**SENIOR CENTER
15 LOUIS LANE
COLCHESTER, CT 06415
BID #2022-013**

S/P+A PROJECT #20.003

DATE: October 6, 2022

The following changes to the Drawings and Project Specifications shall become a part of the Drawings and Project Specifications; superseding previously issued Drawings and Project Specifications to the extent modified by Addendum #2.

1 ATTIC LEVEL DUCT PLAN
1/8" = 1'-0"

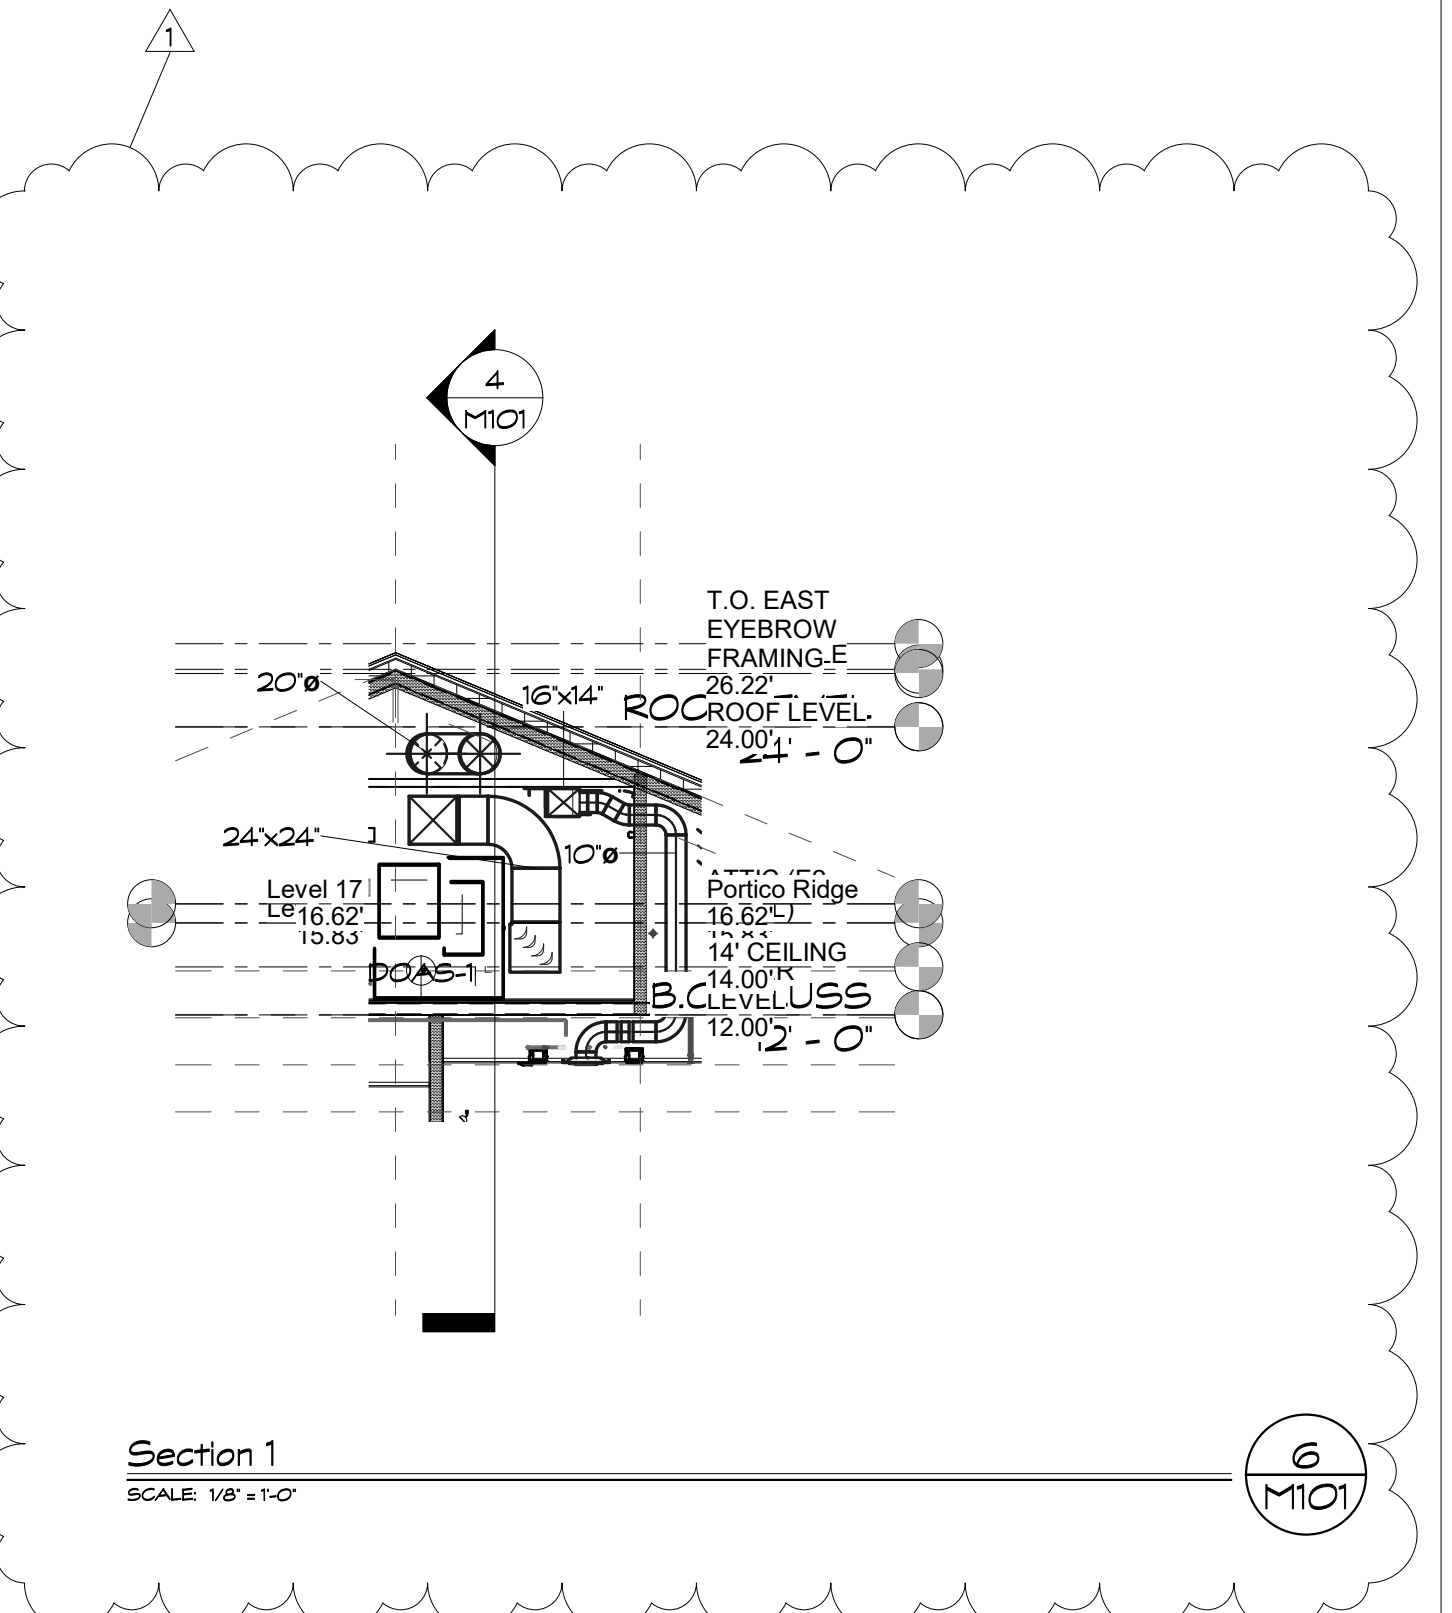
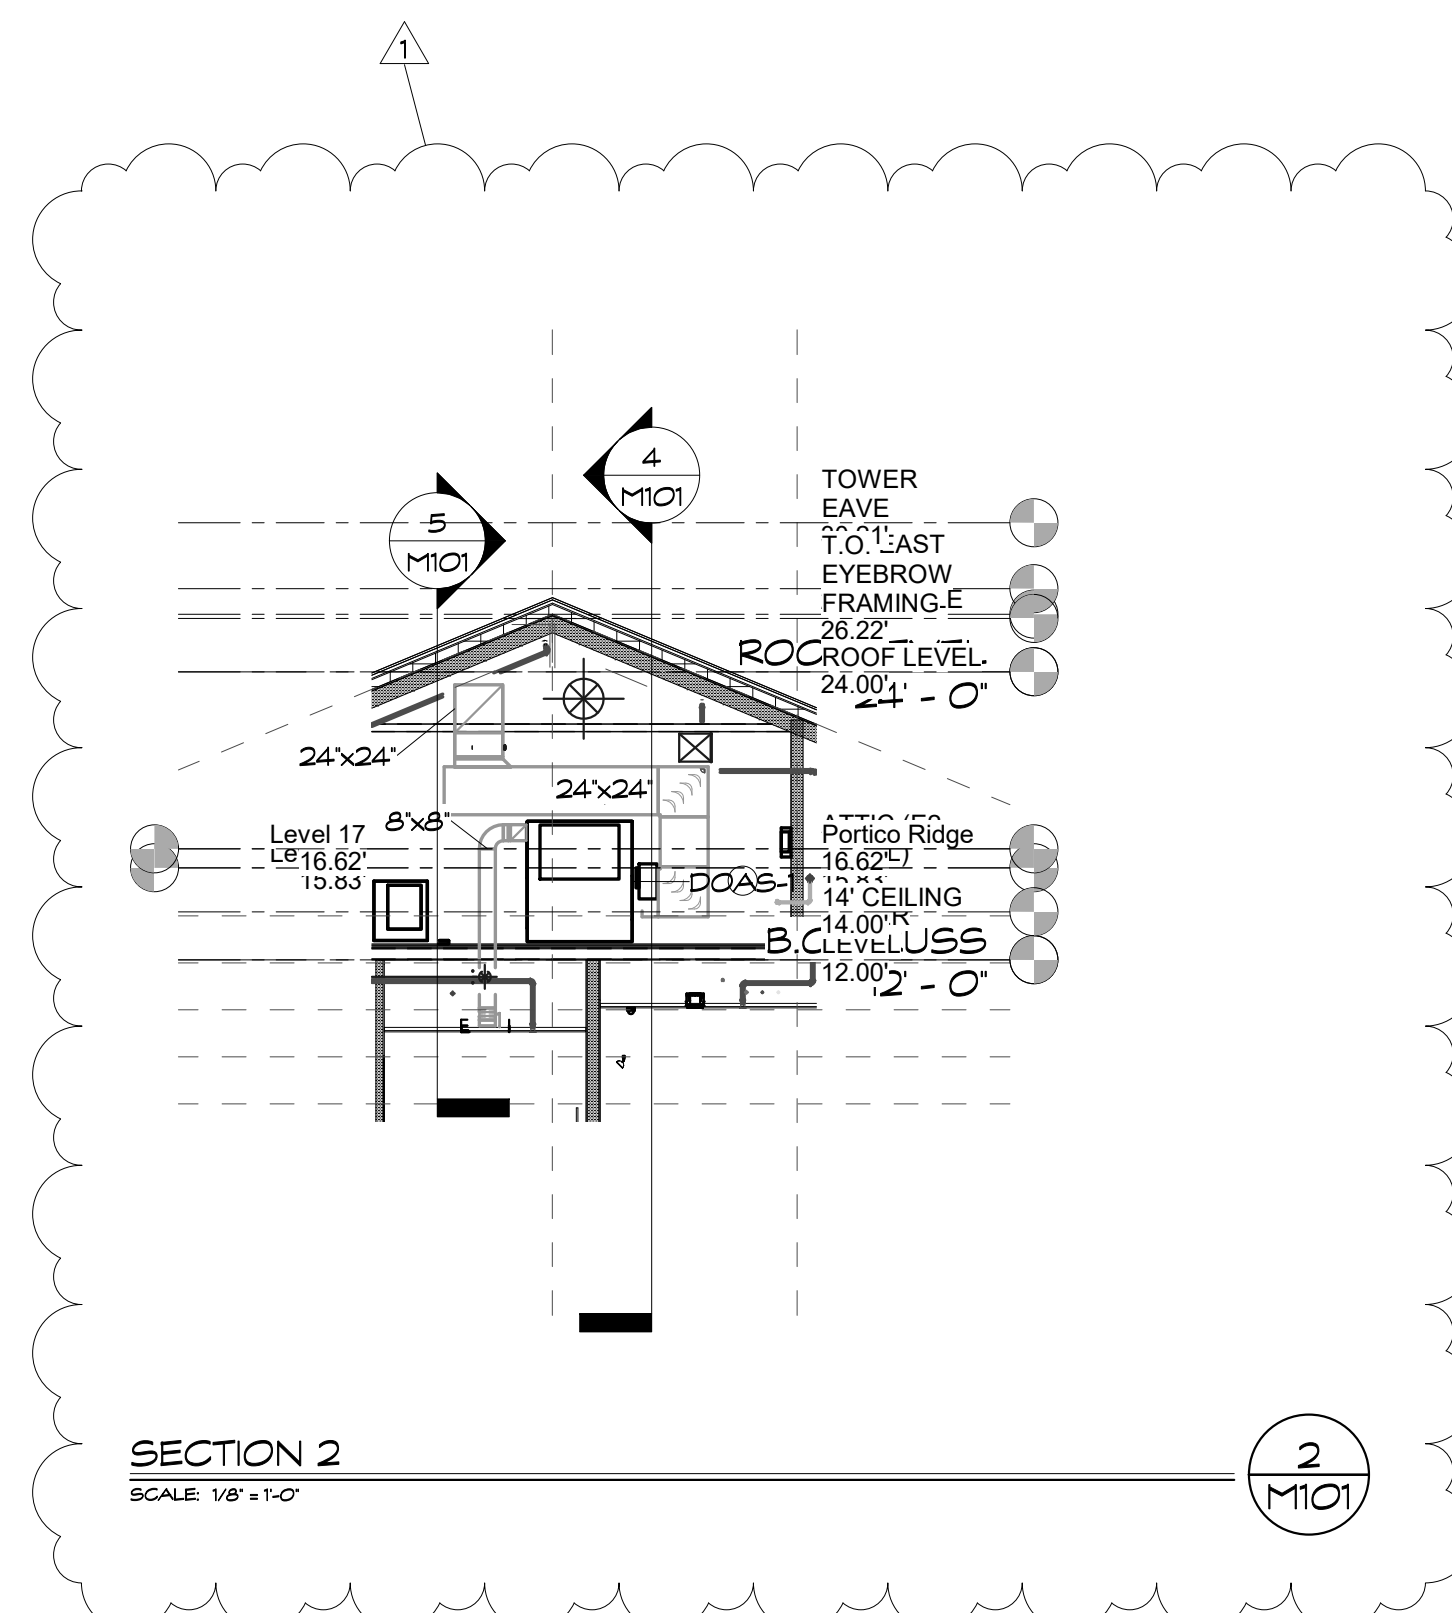
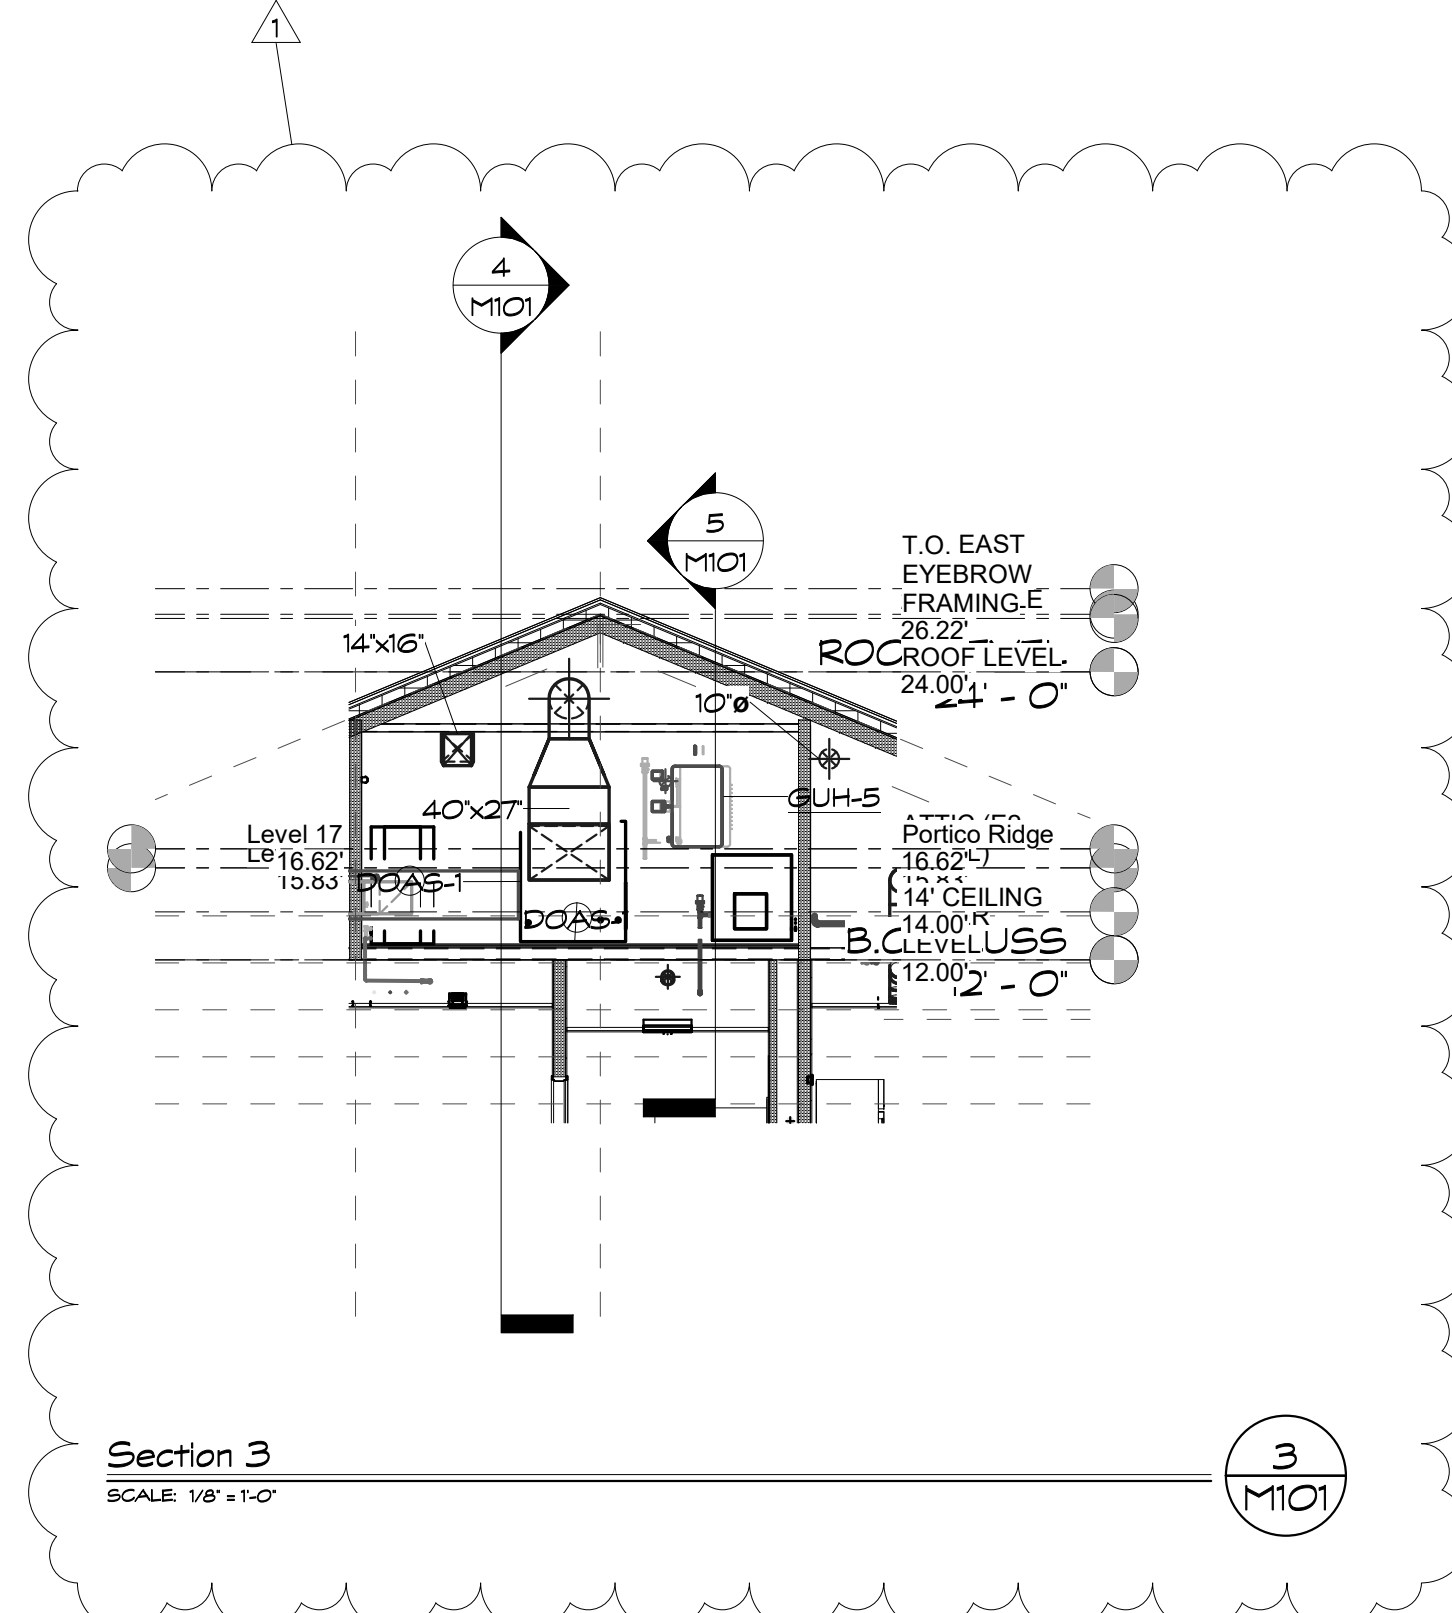
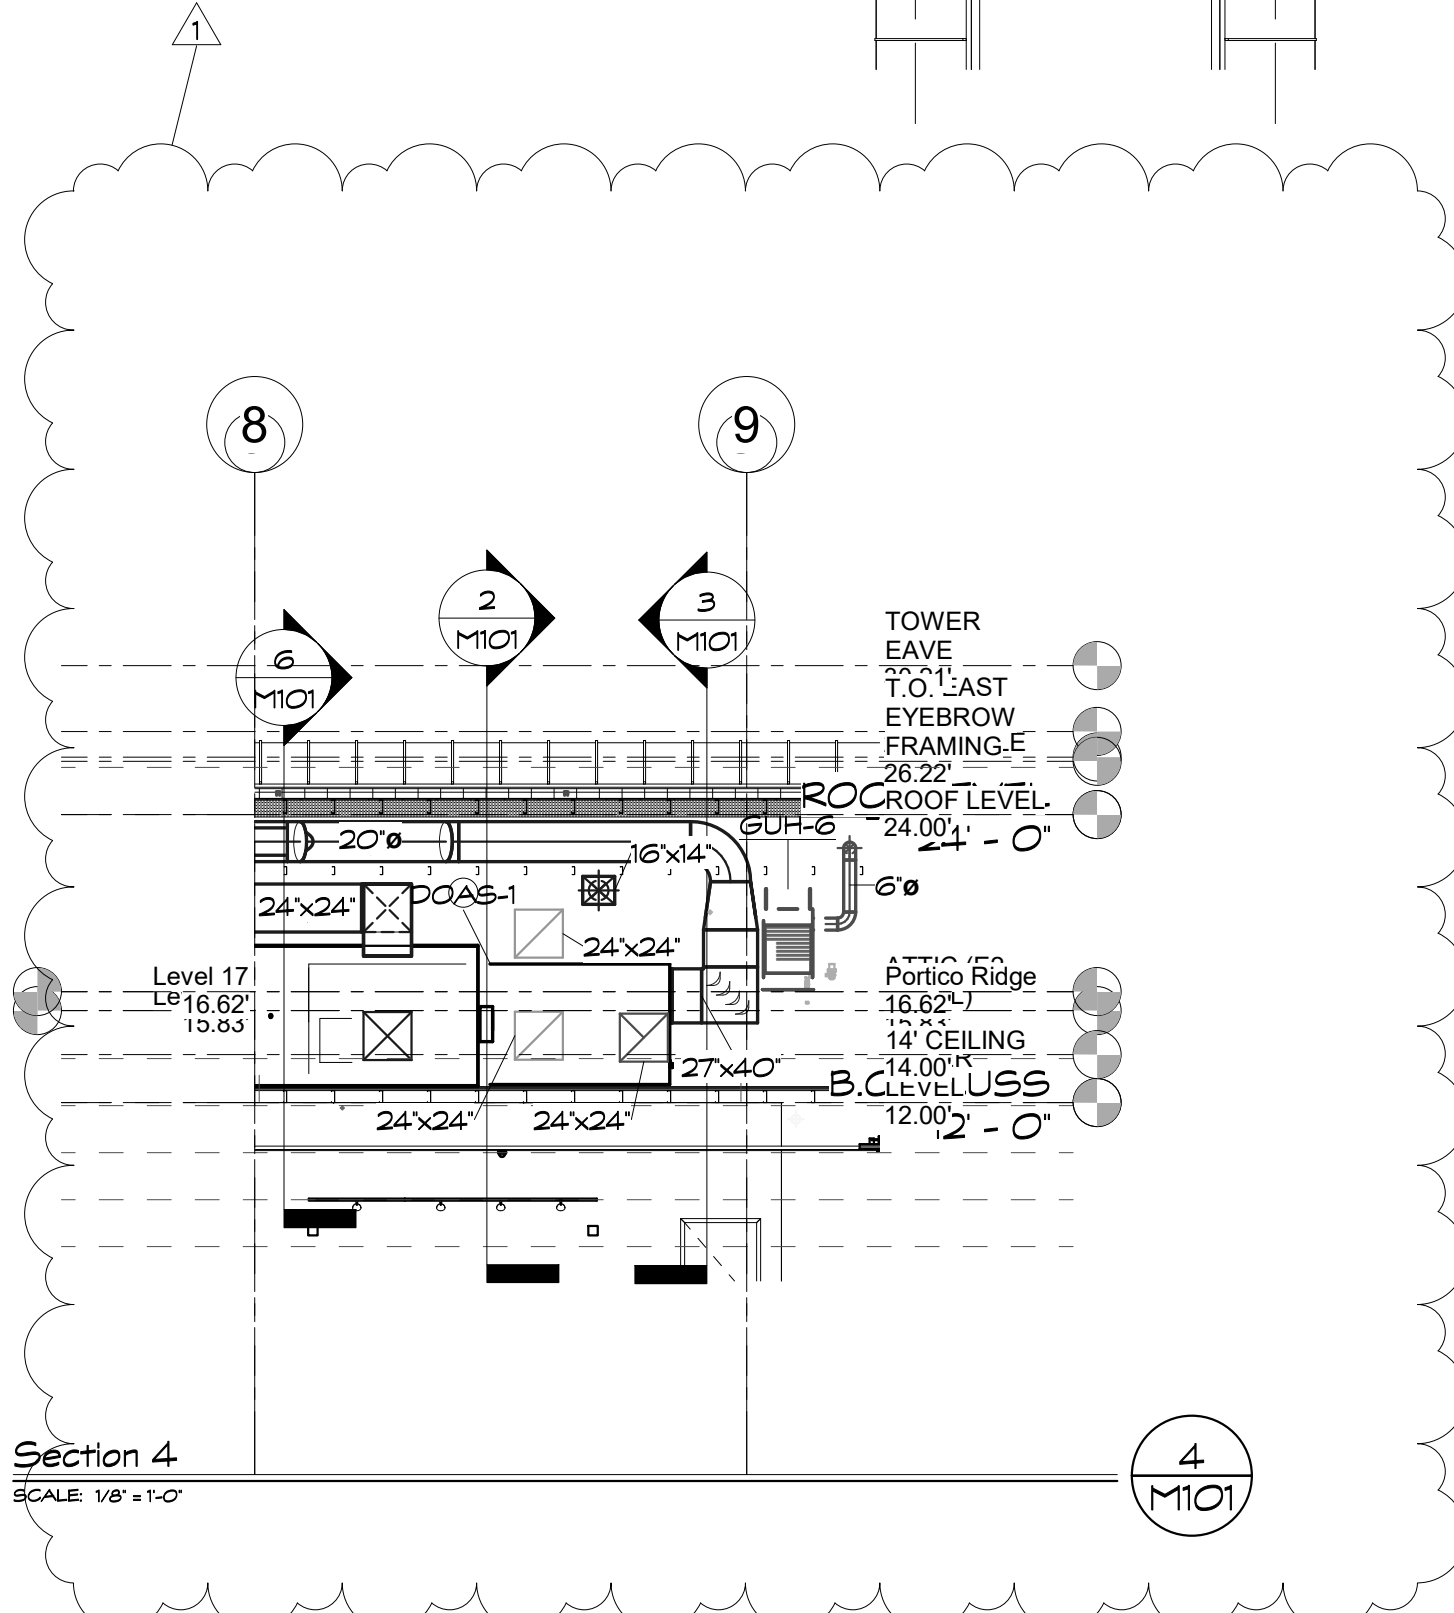
006	Please provide detailed ductwork information around the DOAS unit.	09/20/22	Refer to Addendum #2 for revised Drawings.	2
007	Is there any possibility that the bid date would be extended?	09/20/22	Bid date has been extended. Refer to Addendum #1.	1
008	Regarding the window treatments, the specs call for shades with a front fascia, but detail 2/A550 shows a recessed shade box. Details 7/A550 and 1/A552 also show a shade box below the ceiling. Please clarify if all shades are to receive front fascia only, or if some will be requiring shade pocket (recessed or surface mounted).	09/21/22	Window treatments are to have a front & back fascia (also referred to as a headbox). This headbox is to be installed exposed and recessed as indicated in the Drawings. Refer to Addendum #1.	1
009	Can the bid be extended 1 week?	09/21/22	Refer to RFI #007.	1
010	Are lockers included in this project? If so, please provide specs.	09/21/22	No.	1

- DRAWING M502, MECHANICAL DETAILS has been added and is attached as part of this addendum.*
